**Village of Royal Palm Beach
Village Council
Agenda Item Summary**

PUBLIC HEARING TO CONSIDER APPLICATION NO. 22-71 (SPM, AAR) AN APPLICATION BY CENTERPOINT INTEGRATED SOLUTIONS, LLC. AND ADOPTION OF RESOLUTION 23-28 CONFIRMING COUNCIL ACTION. THE APPLICANT IS SEEKING SITE PLAN AND ARCHITECTURAL APPROVAL IN ORDER TO CONSTRUCT A STANDALONE BUILDING WHICH WILL BE UTILIZED FOR A VEHICLE AUCTION USE, FOR A PROPERTY LOCATED AT 10501 SOUTHERN BOULEVARD; BY MICHAEL CARR OF LANGAN ENGINEERING.

Village of Royal Palm Beach - Staff Report

Application: 22-71 (SPM, AAR) (Res. 23-28)

Attachment C **Site Plan** **Carmax** **Application No. 22-71 (SPM, AAR)** **Resolution No. 23-28**

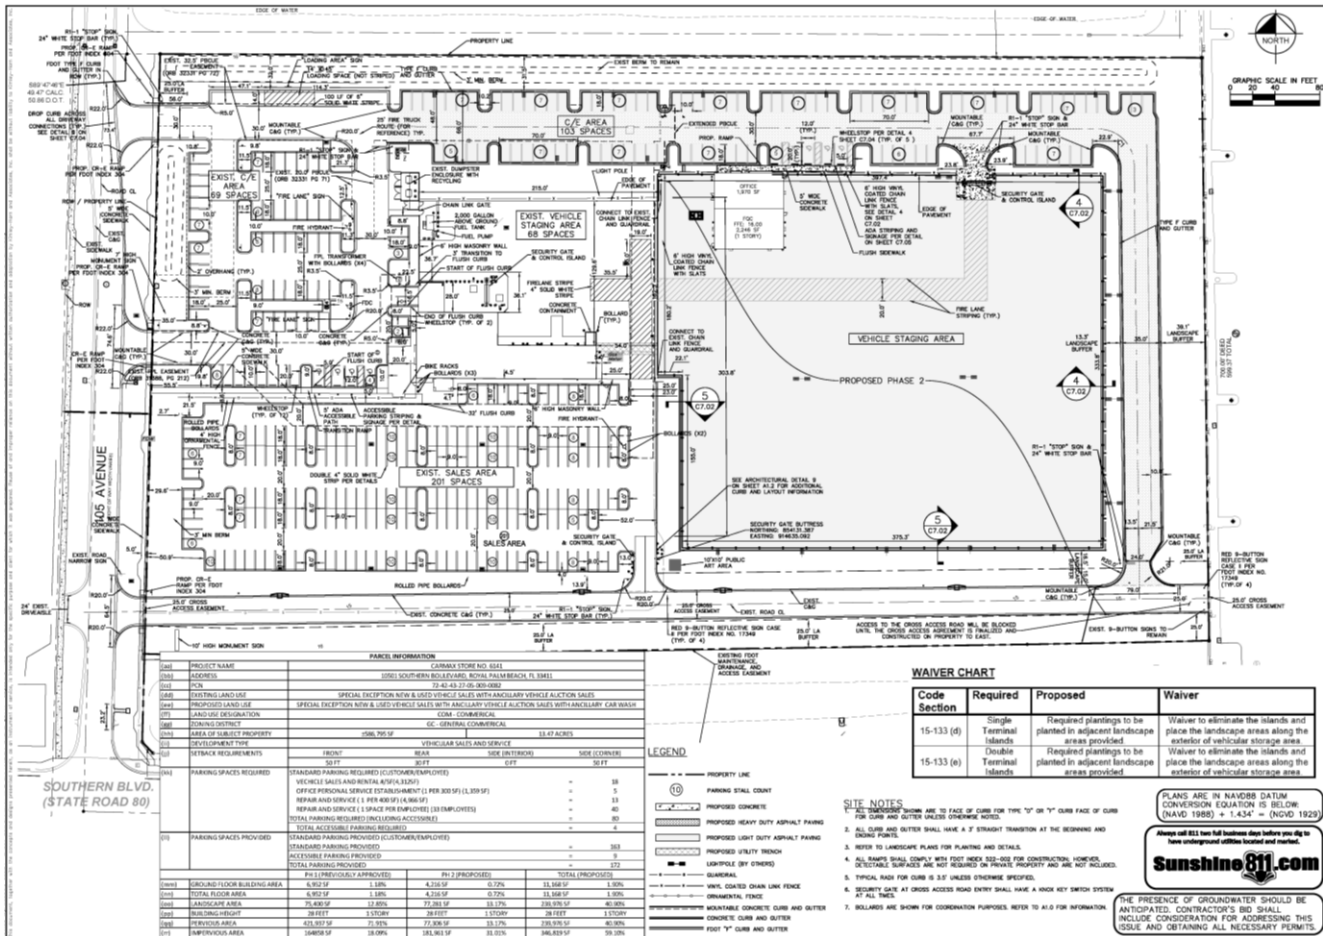
Village Staff is not in support of the proposed Site Plan and Landscape Plan. The Applicant is proposing a 2.6 acre paved parking area that will serve as a storage area for the auction vehicles. This area will be void of any striping or terminal landscape islands. Directly below is an aerial photograph of the storage area for auction vehicles at the CarMax location in Boynton Beach.

Village Staff feels as though striping and landscape terminal islands are essential in promoting a safe and well-organized parking area. Creating parking stalls with the use of striping promotes a predicable parking pattern and also defines drive aisles for pedestrians and vehicles navigating to, around and through these areas. Without an established parking pattern with appropriate striping and terminal landscape islands, Village Staff feels as though the Site Plan and the Landscape Plan do not meet certain sections of Village Code designed to promote predictability and enhance pedestrian and vehicular safety to, around, and through such parking fields. The following are Village Code Sections which aren't being met by the application as currently proposed:

- Section 23-49 *Off-Street Parking Requirement*, subpart (b) *Location and Design Requirements*, subpart (2) *Pedestrian Access* states that "a. All properties **shall** provide safe, adequate and direct pedestrian access between a building, structure, or use (vehicle auction area) and its associated parking area."

Village Staff contends that without a well striped parking area along with defined vehicular drive aisles, the Site Plan cannot demonstrate that a safe, adequate and direct pedestrian access is being provided to, around and through the vehicle auction area.

- Section 23-49 *Off-Street Parking Requirement*, subpart (b) *Location and Design Requirements*, subpart (3) *Internal circulation* states that "c. Internal circulation areas **shall** be designed so as to not interfere with or pose a hazard to any parking spaces, loading spaces, or pedestrian movements."

Village Staff contends that without a well striped parking area along with defined vehicular drive aisles, the Site Plan cannot demonstrate that the internal circulation areas do not interfere with or pose a hazard to pedestrian movements to, through, and around the vehicle auction area.

Overall, the proposed Site Plan, Special Exception and Architecture meet all of the Village's requirements for this type of use in the General Commercial (CG) Zoning District with the exceptions noted above. Village Staff believes that without a well striped parking area along with defined vehicular drive aisles, the Site Plan cannot demonstrate that a safe, adequate and direct pedestrian access is being provided nor demonstrate that internal circulation areas do not interfere with or pose a hazard to pedestrian movements to, through, and around the vehicle auction area, therefor Staff is recommending Denial of this application.

Attachment D
Site Plan
Carmax
Application No. 22-71 (SPM, AAR)
Resolution No. 23-28

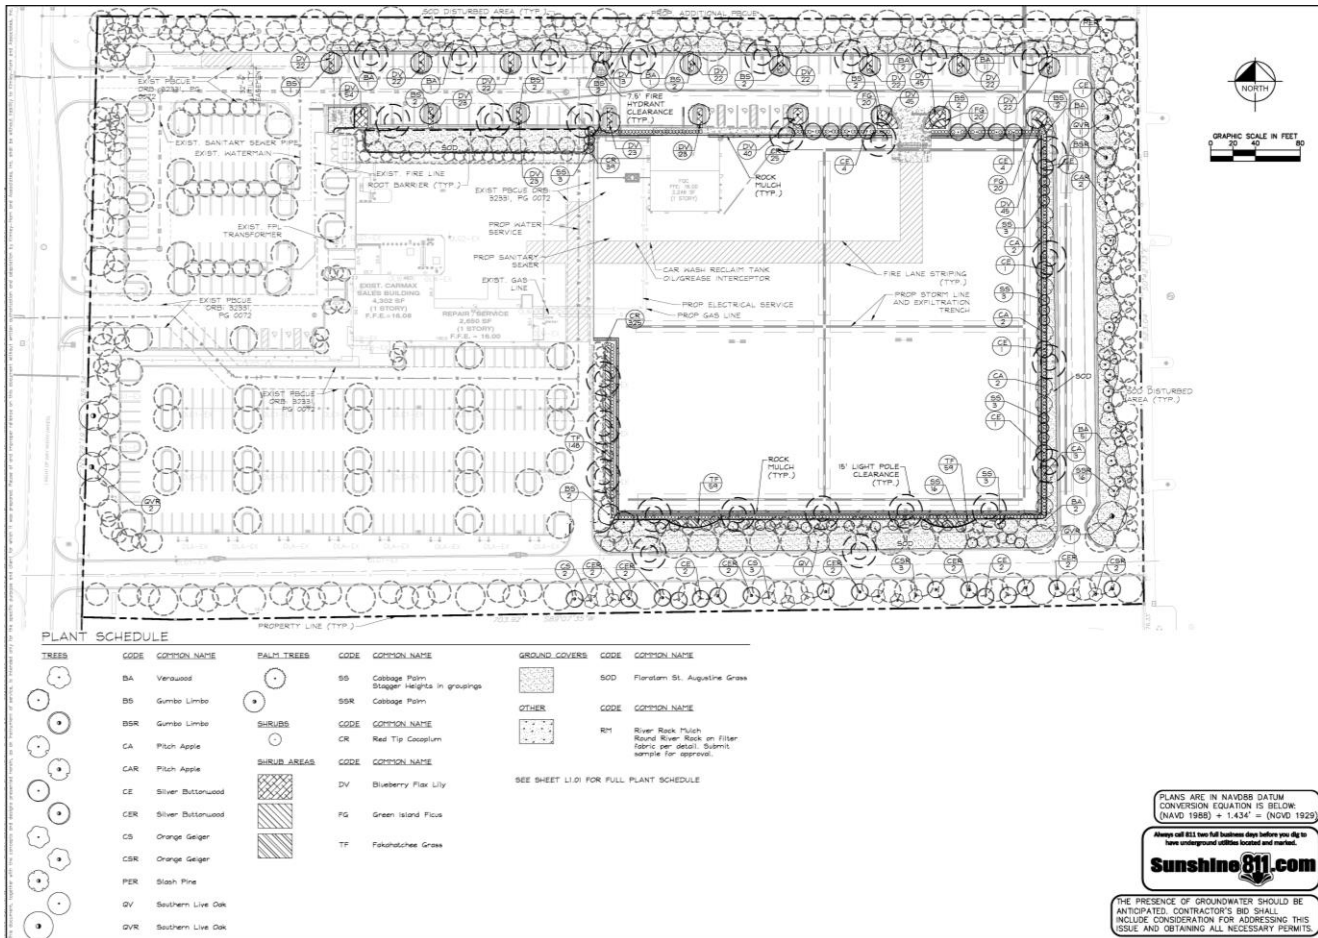
Village Staff contends that the proposed 2.6 acre asphalt parking field does not meet the review criteria for Landscape Plans in that the proposed parking field is void of any landscaping which does not promote an inviting and stable appearance (criterion #2); is void of any landscaping to provide shade (criterion #3); and is void of trees and shrubs in paved areas (criterion #5).

6. Landscape Areas: The Landscape Plan does not meet all of the landscape requirements of the Village Code. The Applicant is requesting the elimination of the landscape islands within the vehicle parking area of the "Vehicle Auction" area through a separate Landscape Waiver application.
